**FORD:**

2015-2017 F-150

This article supersedes TSB **15-0052** to update the vehicle model years, Service Procedure and Part List.

**ISSUE**

Figure 1 - Article 16-0155

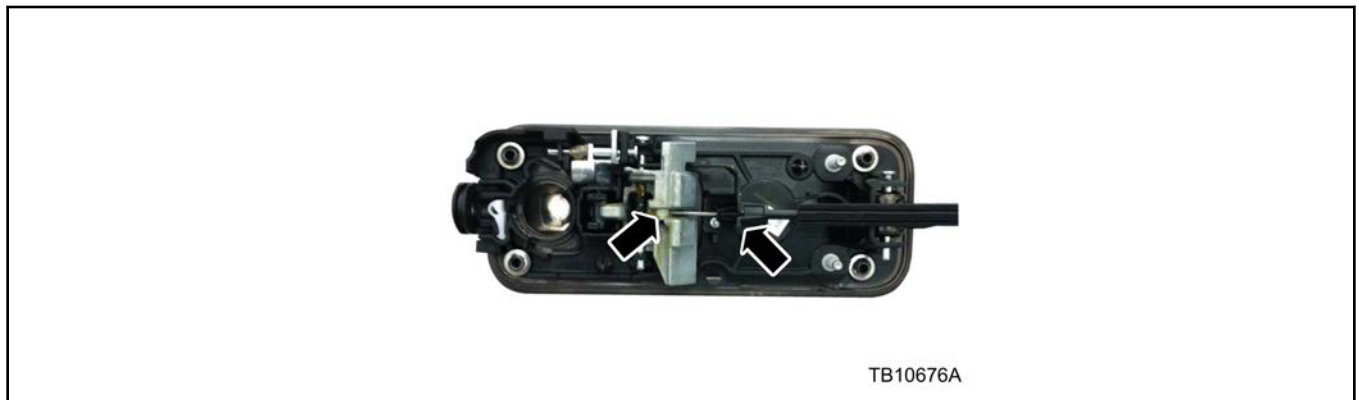
1. Remove both front door interior door panels on all vehicles and both rear door interior door panels only on SuperCrew vehicles. Refer to Workshop Manual (WSM), Section 501-05.
  - a. Remove door water shield for access.
  - b. Verify the latch release cable is properly seated and the cable end is properly installed on to the outer handle. (Figure 1)

- c. If improper installation is found and the cable has become kinked, the cable should be replaced. Refer to WSM, Section 501-14.
2. Remove both front door latch assemblies on all vehicles and both rear door latch assemblies only on SuperCrew vehicles. Refer to WSM, Section 501-14.
3. Use compressed air to blow dry all the door latch assemblies after removal and all interior handle assemblies.
4. Replace the door latch retaining brackets. Refer to WSM, Section 501-14.

Figure 2 - Article 16-0155

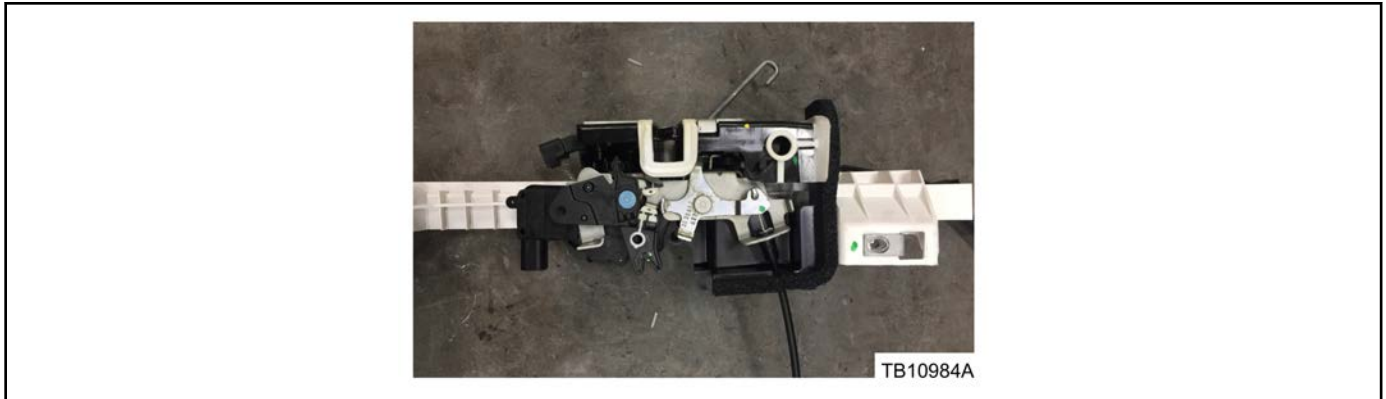
- a. Install the rain shield on the door latch brackets opposite the latch using the supplied hardware. (Figure 2)
